# MANUAL CHANGES

Model Number: 1740A  
 Date Printed: August 1976  
 Part Number: 01740-90909

This supplement contains important information for correcting manual errors and for adapting the manual to instruments containing improvements made after the printing of the manual.

Service Schematic 4,

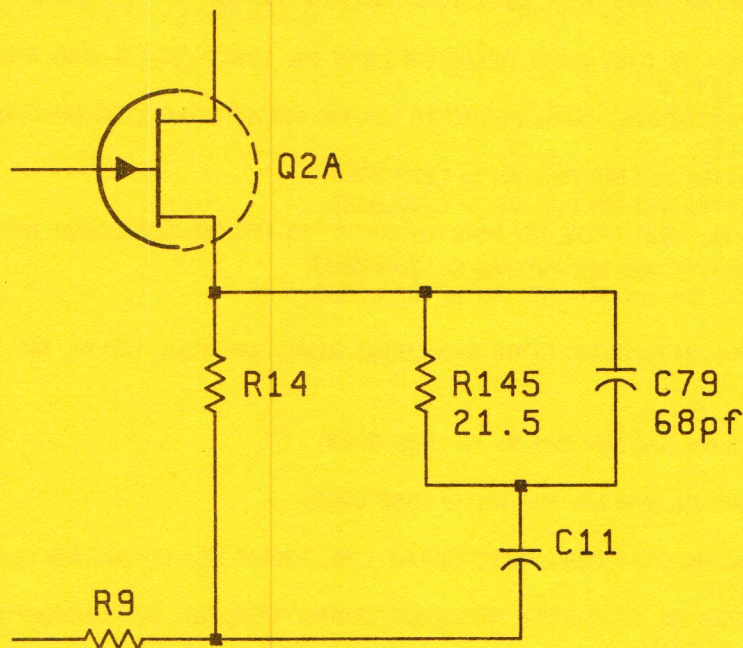
Add: A3R145 and A3C79 in series with A3C11 to Channel A, as shown.

Add: A3R146 and A3C80 in series with A3C25 (same as above) to Channel B.

Schematic 1,

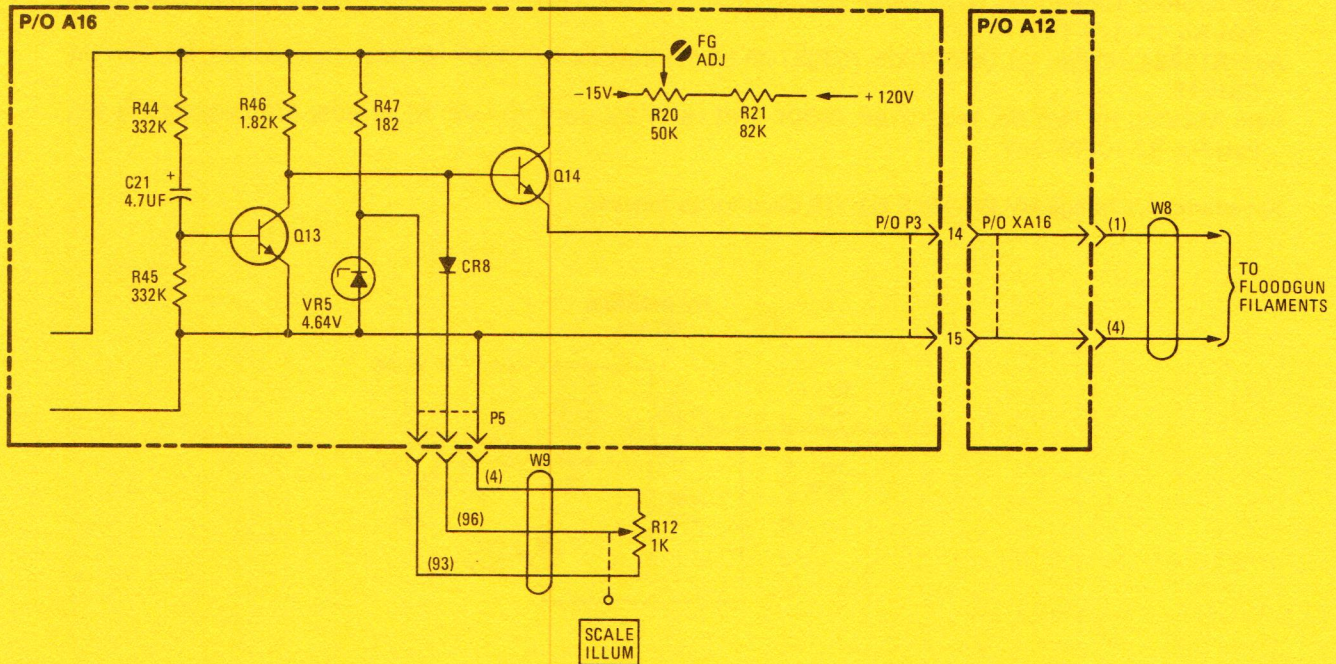
Delete: A16C20, A16Q11, A16Q12, A16R41, A16R42, A16R43, A16VR3, and A16VR4.

Add: A16C21, A16CR8, A16P5, A16Q13, A16Q14, A16R44, A16R45, A16R46, A16R47, and A16VR5 as shown below:
